<b>Wulfsberg Electronics</b> <i>A Chelton Group Company</i>				
APPROVALS				DATE		
DRAWN	Leslie Evans	8/2/07	<b>TITLE:</b> <b>SERVICE NOTIFICATON, WSN C-5000-18</b> <b>REDUCE SPACE BETWEEN REAR MATING CONNECTORS TO IMPROVE CONDUCTIVITY</b>			
CHECKED	Jay Jensen	8/2/07				
PRODUCT MANAGER						
ENGINEER	Jay Jensen	8/8/07	SIZE	CAGE CODE	DWG NO.	REV
ISSUED	Leslie Evans	8/8/07	A	1B7G3	150-042385	A
<b>Typed signatures indicate approval. Handwritten signature approval of this document is on file at Wulfsberg Electronics, Prescott, Arizona.</b>			SCALE: NONE		DO NOT SCALE DRAWING

## SERVICE NOTIFICATION

**EQUIPMENT: C-5000**

**SERVICE NOTIFICATION NUMBER: WSN C-5000-18**

Figure 1A and B

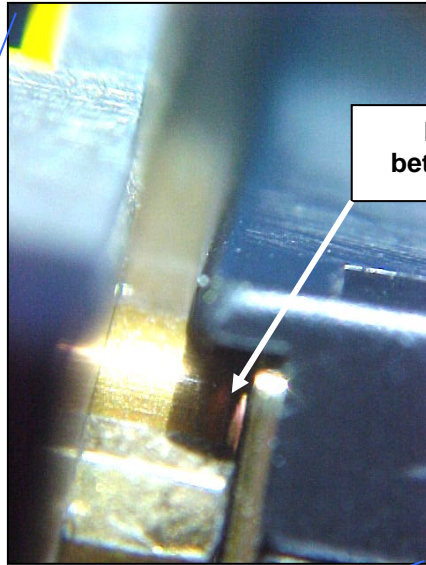
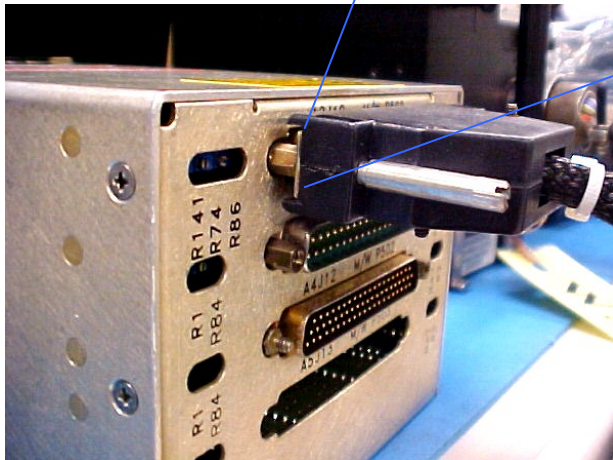
Variance in washer use and jackscrew/spacer depths can prevent mating connectors from seating completely on C-5000 rear connector P500, 501, 502, and/or P503.

Inspect each C-5000 rear connector while mating to the interconnect harness for proper seating (Ref Figure 1).

Inspect for gap between connectors

If washers are present and the gap exceeds the distance between mating connectors the washers may be removed to reduce the potential for vibration to cause intermittent conductivity between mating connectors.

Note: Loctite is present on the jackscrew/spacer hardware.

Note: Jackscrews should be tightened to 5 in/lbs upon replacement.
